Register Reference : 91A/1803

Development : change of house type

LOCATION : site nos. 30, 34, 39, 44, 47, 48, 49 and 54 Orlagh
Grove, Scholarstown Road

Report of Dublin Planning Officer dated 13th December, 1991.

PROPOSED HOUSING DEVELOPMENT AT ORLAGH DRIVE
FOR SHERRILL BOWERS LTD.
SCALE 1:1000
BRUNNENBERG SPARCO, 3 ARCH ST., ARCHITECTS
16, WINDCLIFFE PARK, RIVERVIEW, ILL.
TELEPHONE: 779-9988 • 779-1433
SPARRCO
8.9.91
JONE

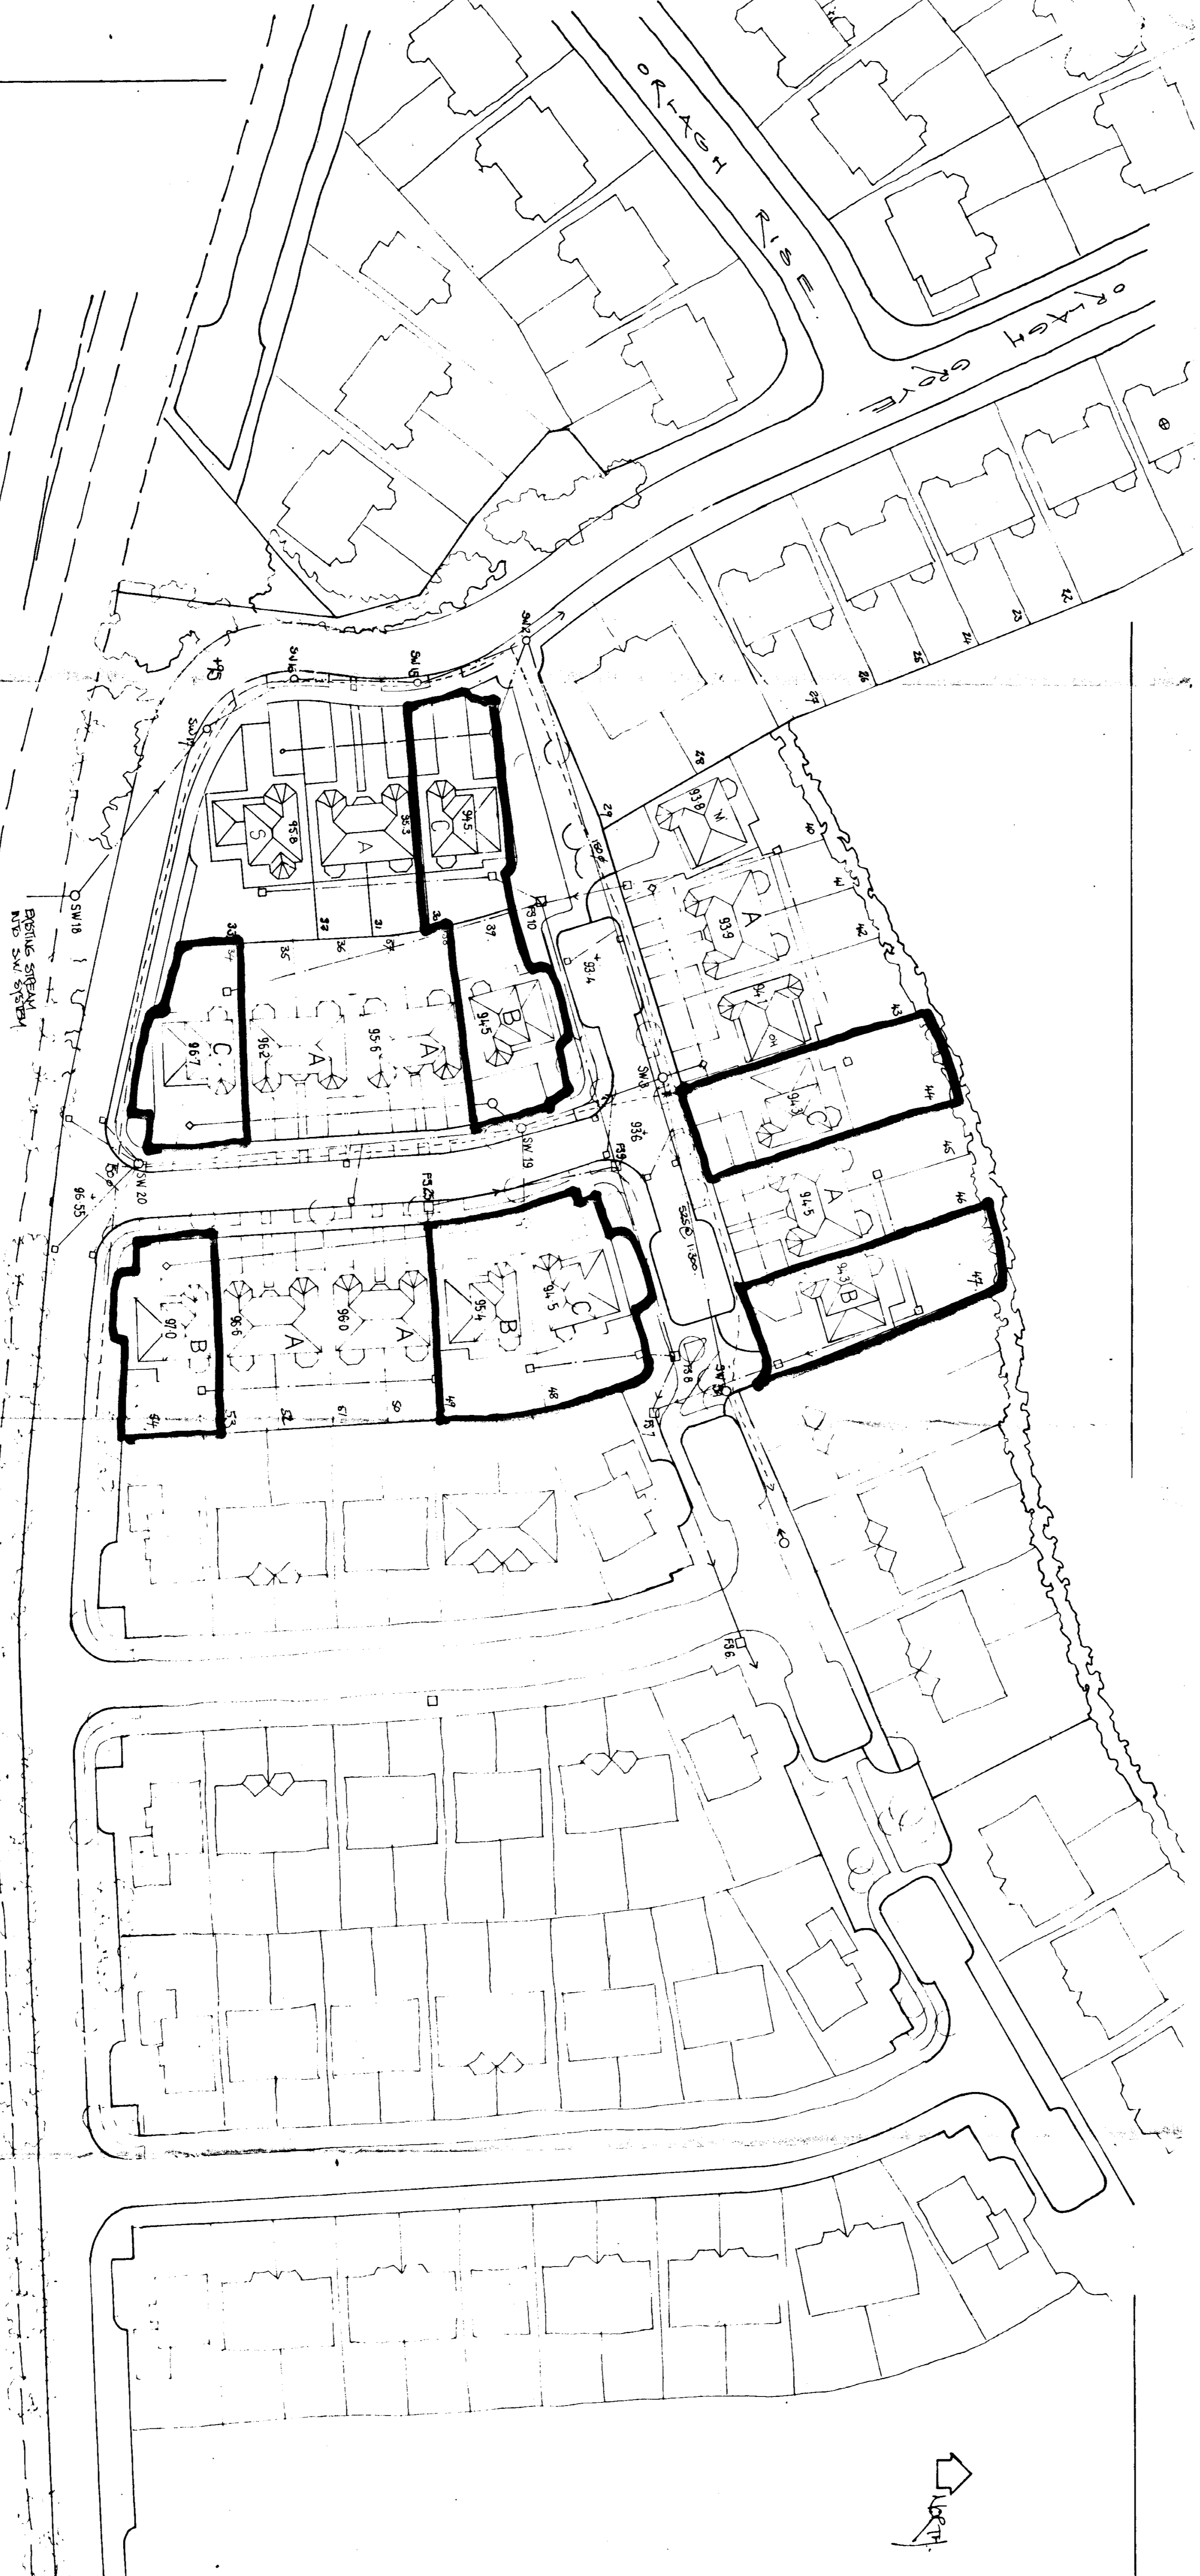
The proposed development will reduce the distance between the proposed southern cross motorway and habitable space within house nos. 34 and 54.

10 No building to be within 5 metres of any proposed public sewer or watermain. The applicant should particularly note that a proposed foul sewer is located only 3.5 metres from house no. 39, ~~which is~~ unacceptable. 2

14 That the permission excludes the change of house types on site nos. 34 and 54.

REASON: In the interest of residential amenity, the proposed development would reduce the distance between habitable space in these houses and the proposed reservation for the southern cross motorway to an unacceptable level and would be contrary to the proper planning and development of the area.
